Appendix I of RNTPC
Paper No. A/HSK/477

Proposed Temporary Reinforcing Steel
Processing Workshop with Ancillary Office
for a Period of 3 Years at Lot 1262(Part)
in D.D. 124, Ha Tsuen, Yuen Long

Technical Support For The Proposed Temporary Reinforcing Steel Processing Workshop With Ancillary Office For A Period Of 3 Years
At Lot 1262 (Part) In D.D. 124, Ha Tsuen, Yuen Long

Responses to Comments from Drainage Services Department (A/HSK/230)

Figures 4.1 - Typical Section Between Subject Site And Adjacent Site

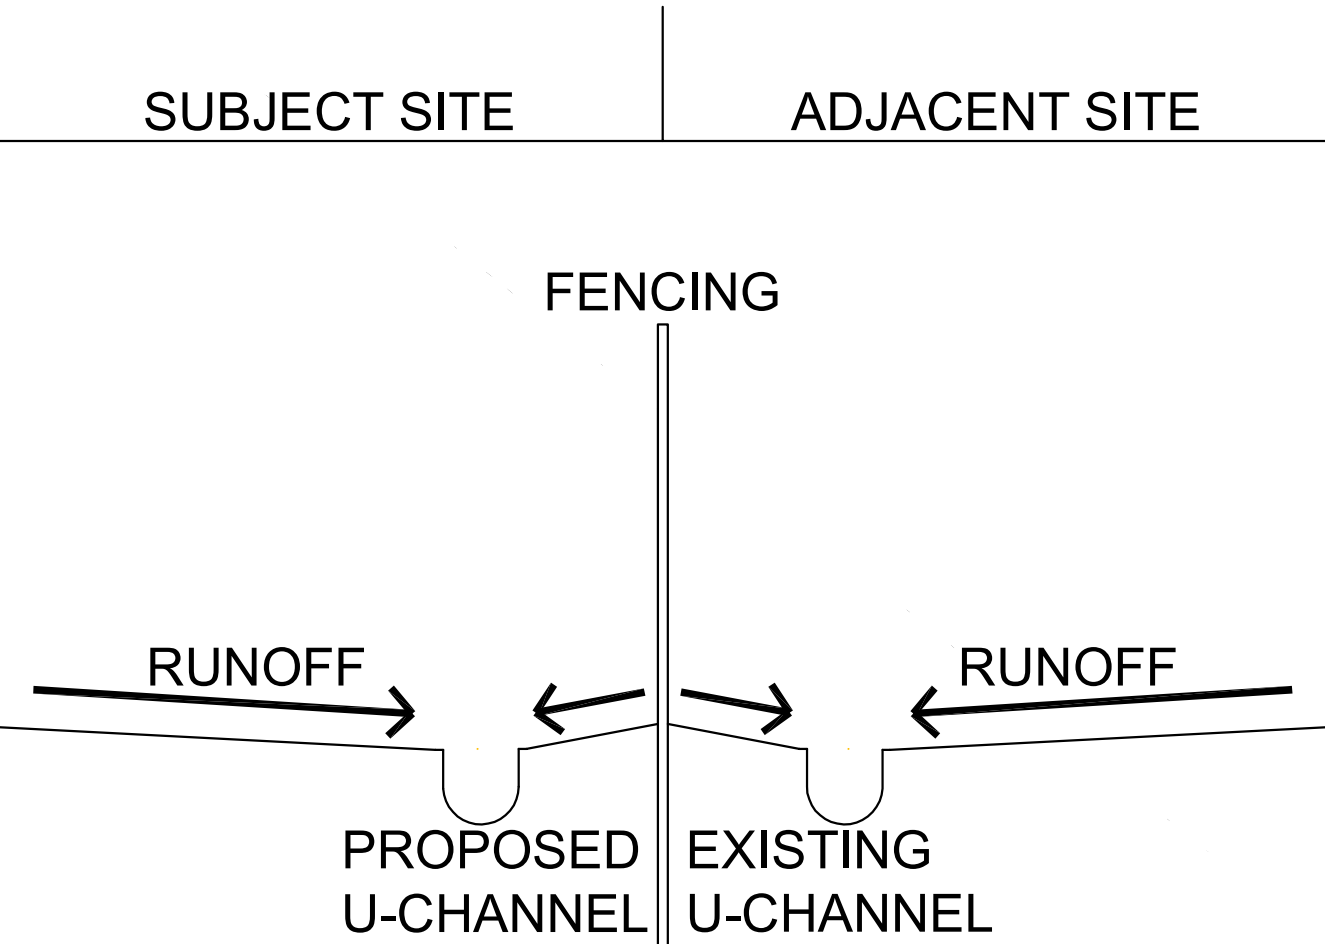
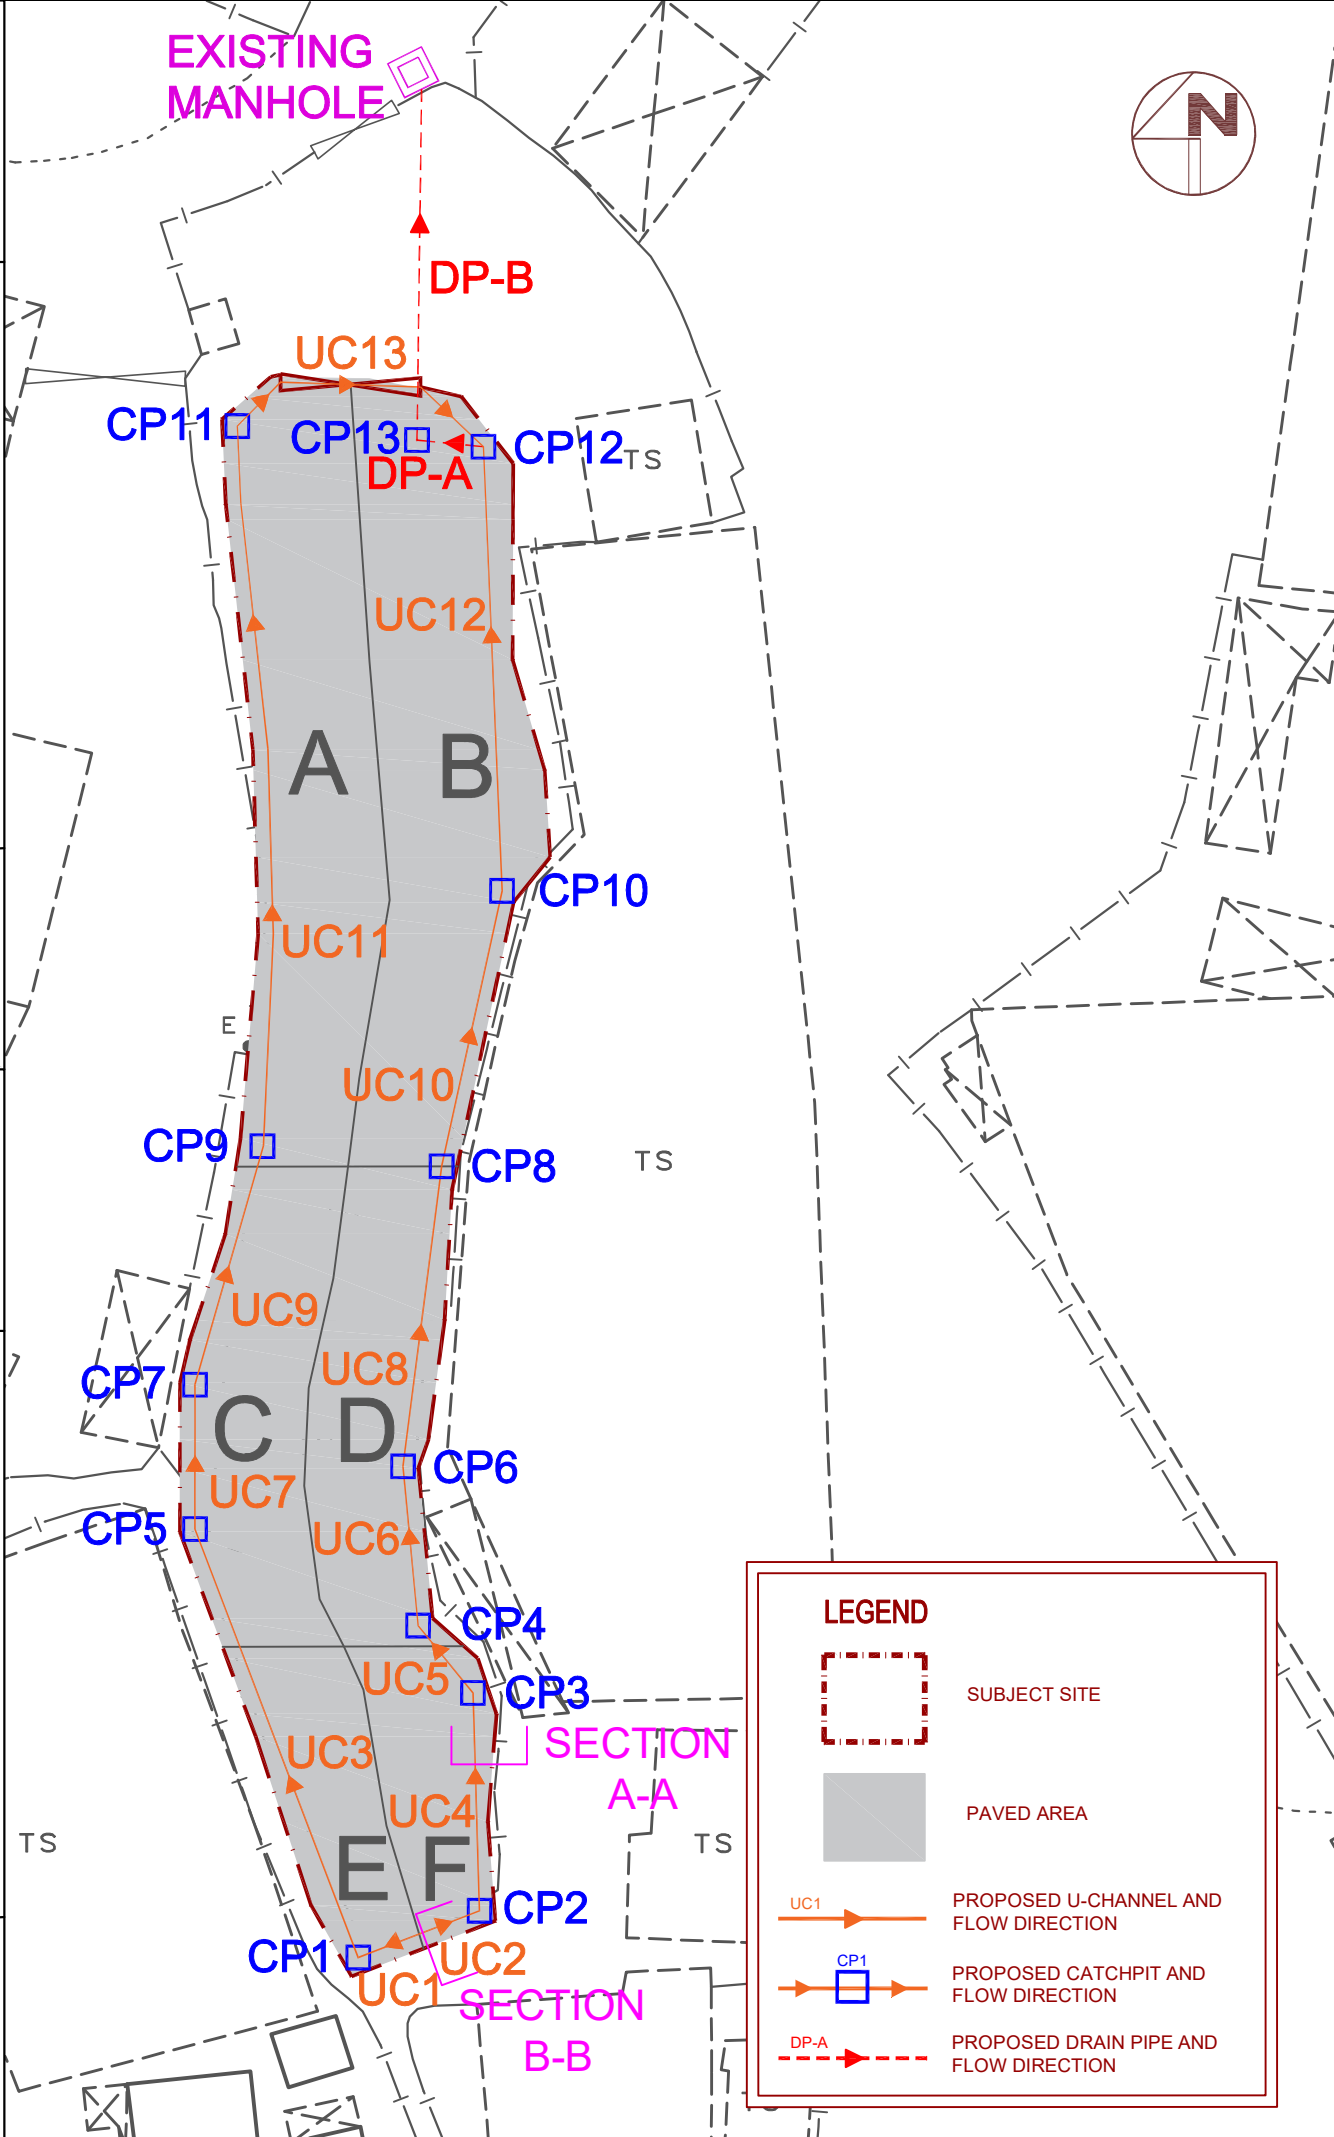
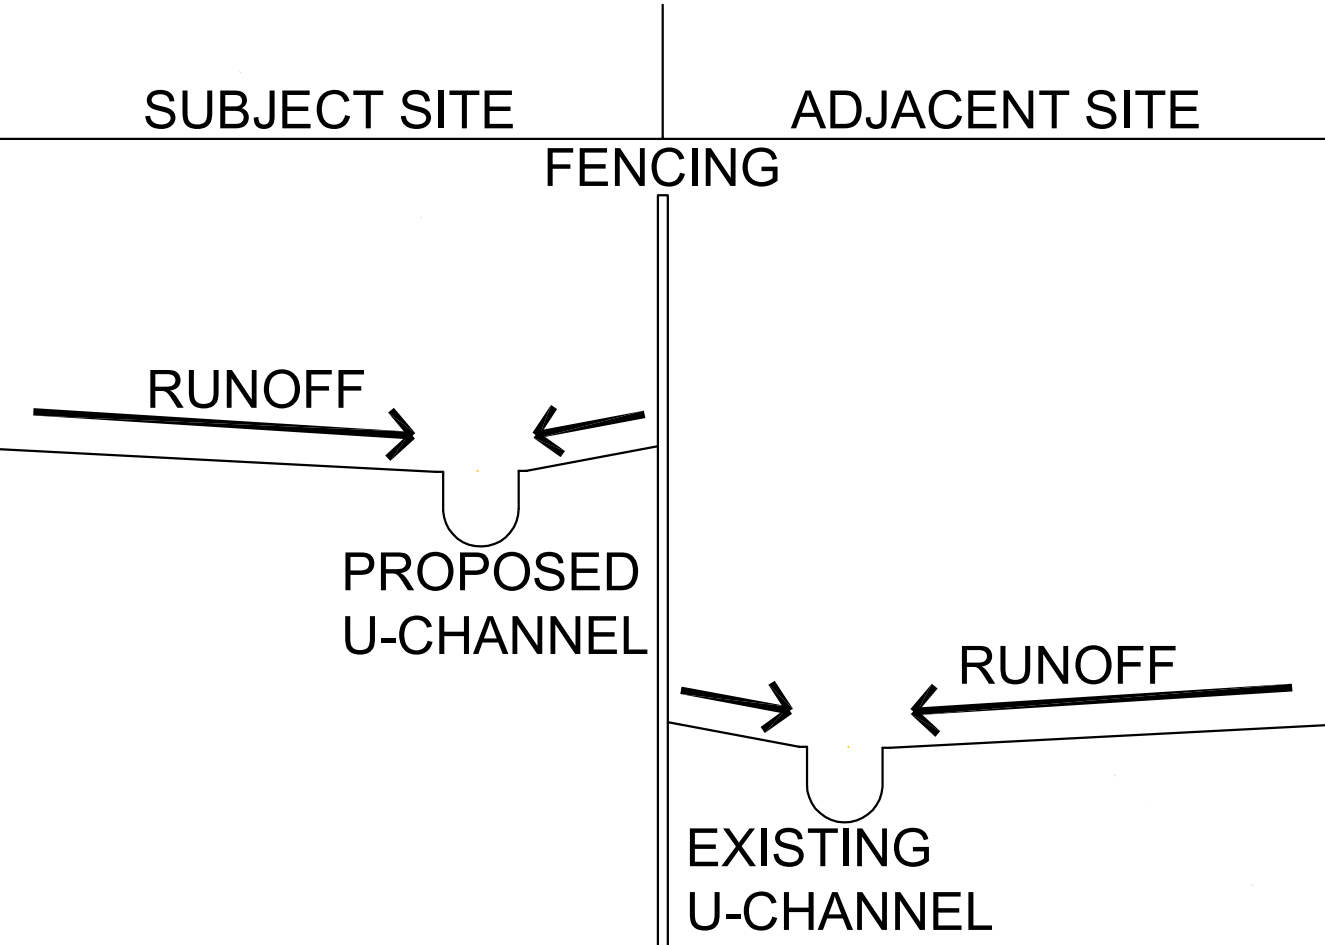
e. Cross sections showing the existing and proposed ground levels of the captioned site with respect to the adjacent areas should be given;	Figures 4.1 in Appendix B to this RtoC depict the cross sections between the captioned site and adjacent areas and it has been observed that sites adjacent to this one have adequate drainage facilities, as shown in the photographs in Annex 1 of the Drainage Proposal.
